Addendum 04

PROJECT: Allen County Board of Developmental Disabilities – Miscellaneous Projects
2500 Ada Road
Lima, OH 45801

PROJECT #: 25092.00

SHEET NUMBER:
M5.1

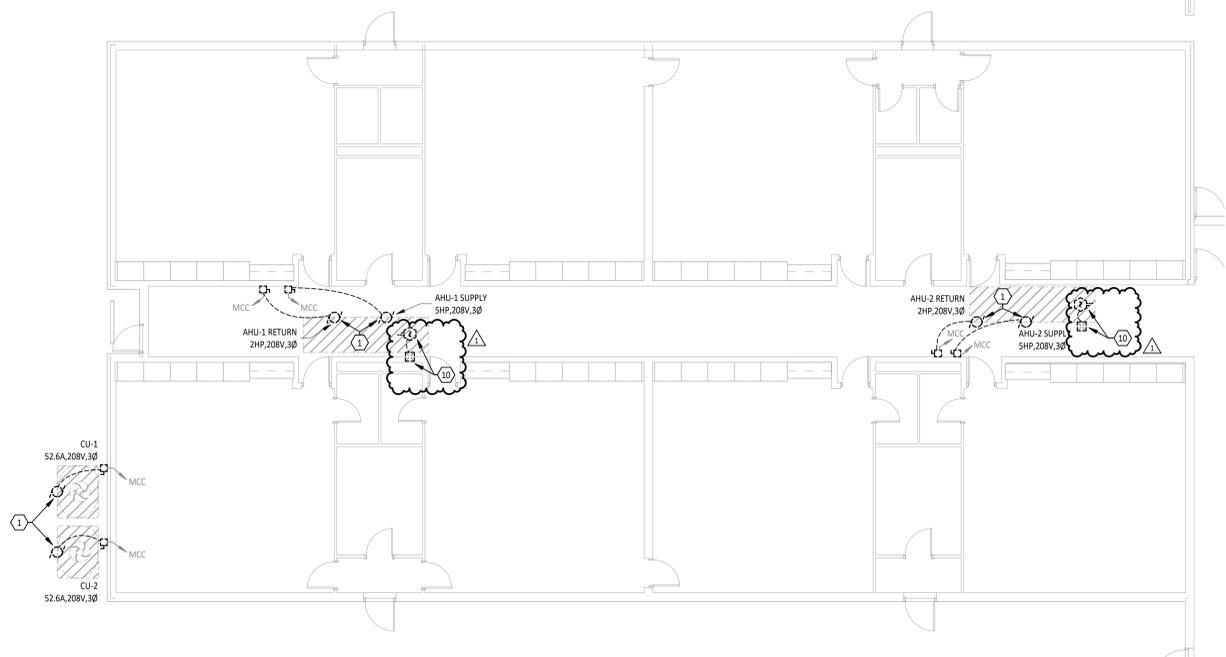
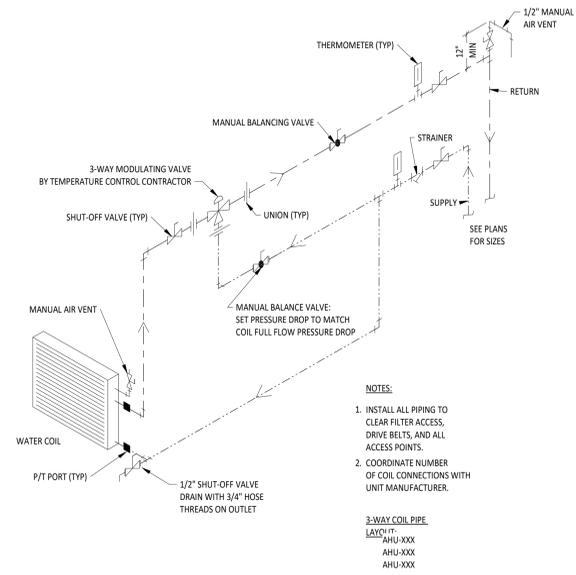
1. Drawing Sheet M2.1 FIRST FLOOR MECHANICAL PLAN - OVERALL: Detail 1 ENLARGED MECHANICAL ROOM PLAN: Change flue size from each boiler, increase size from 6" to 8".
2. Drawing Sheet M5.1 MECHANICAL SCHEDULES: CIRCULATING PUMP SCHEDULE: Change design flow to 85 GPM.
3. Drawing Sheet M5.1 MECHANICAL SCHEDULES: GAS-FIRED BOILER SCHEDULE:
 - a. Change flue category to I.
 - b. Change design flow to 85 gpm.
4. Drawing Sheet ED1.1 ELECTRICAL DEMOLITION PLANS: Detail 1 POWER DEMOLITION PLAN – AREA A and Detail 2 – POWER DEMOLITION PLAN – AREA B: Revised drawings to show existing duct smoke detectors and remote test switches being removed.
5. Drawing Sheet E2.1 ELECTRICAL PLANS: Revised keynote 11 to indicate the new duct detectors shall be connected to the existing wiring/zone salvaged from demolition.
